Product Change Notification

Product Change Notification: PCN-26-290068

ECONOMY POWER TPA

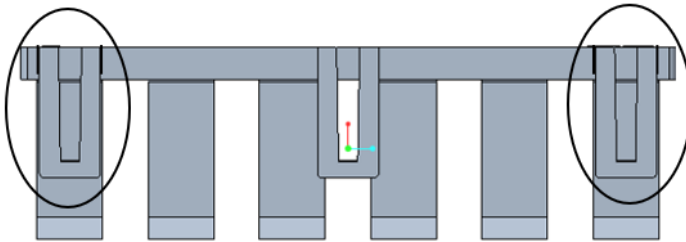
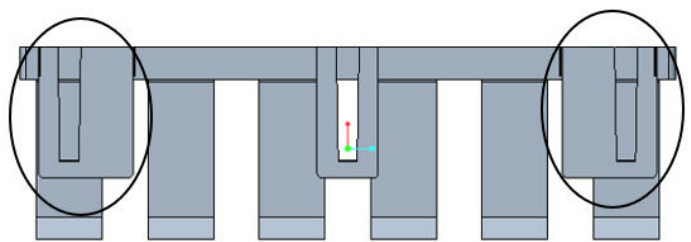
Please be aware of an upcoming feature change to the listed part numbers. The width of the locking latches on both sides add material, no impact on the locking function.

The current locking latch.

The new locking latch.

Update made to prevent the latches on both sides from being inserted into the plug housing holes during TPA assembly.

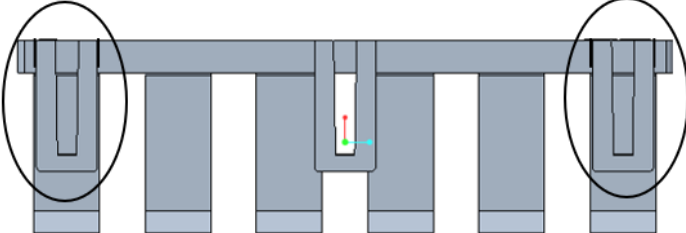
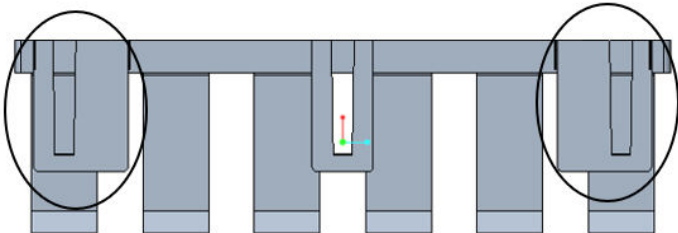
Please be aware of an upcoming feature change to the listed part numbers. The width of the locking latches on both sides add material, no impact on the locking function.

The current locking latch.

The new locking latch.

Update made to prevent the latches on both sides from being inserted into the plug housing holes during TPA assembly.
